Section 73 application - Proposed

project
4*hotel on princess street,
manchester
job no.
7415

title
proposed princess street elevation - section 73 comparison

scale
1:200 @ A3
drawing no.
al(SK)0040

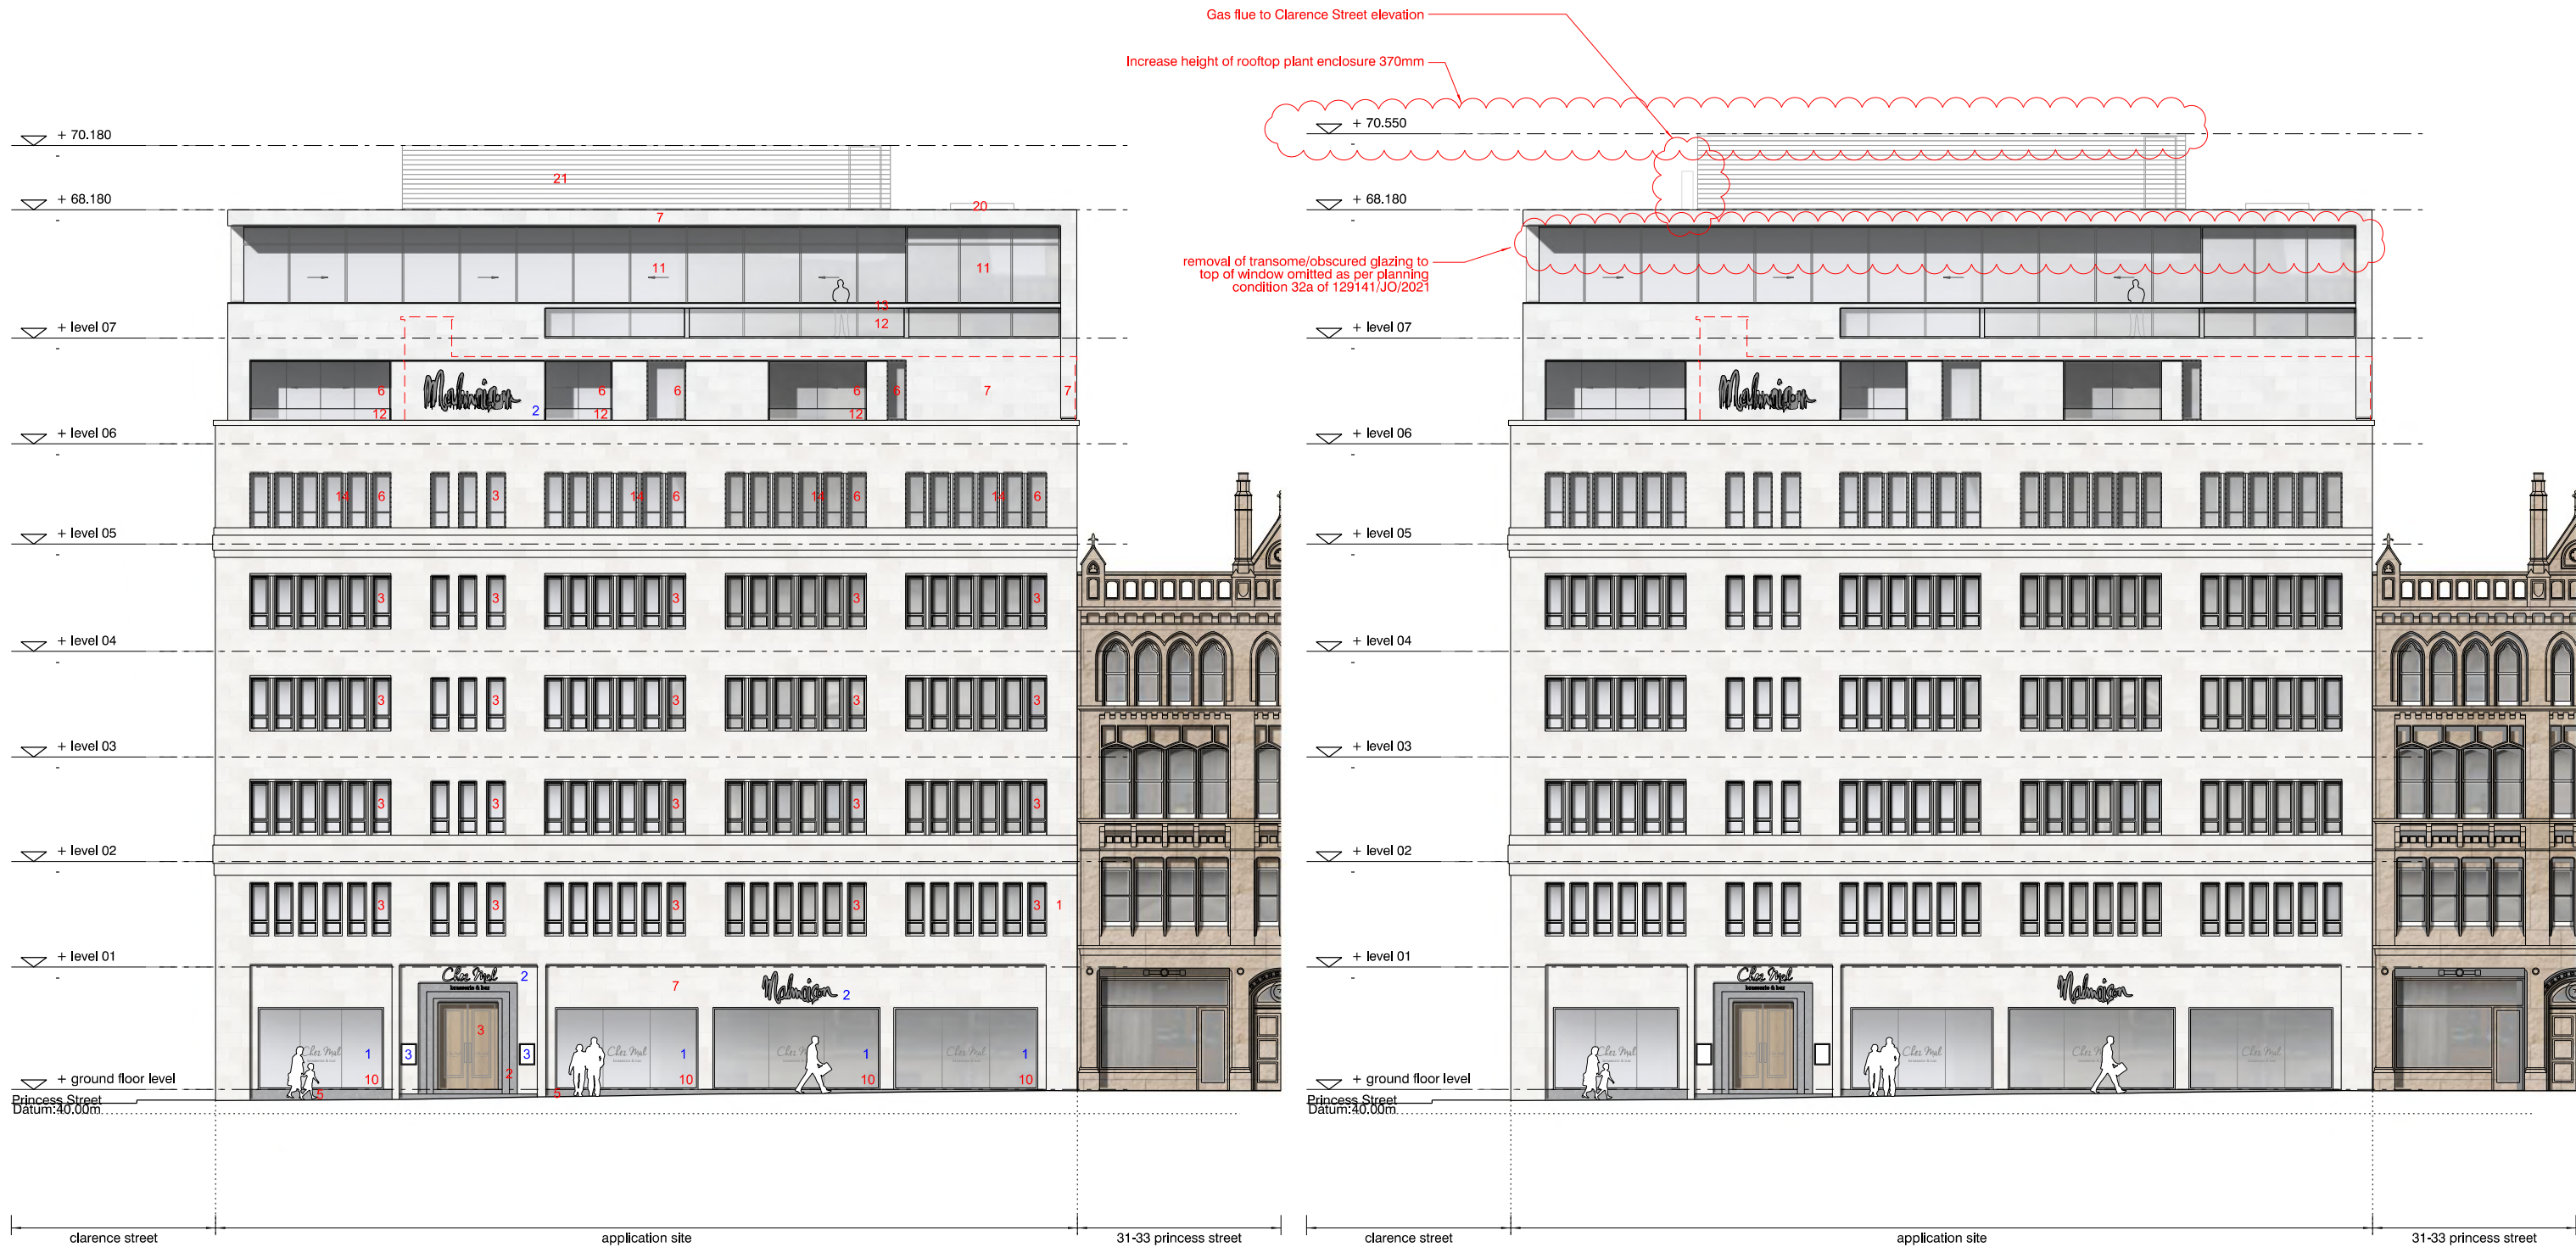
revision: date: note:
P01 20210113 section 73 application
P02 20220824 2nd section 73 application

- 23. handrail to ground floor roof
- denotes amended description
- previous 6th floor level
--- signage zone - detailed design subject to separate application
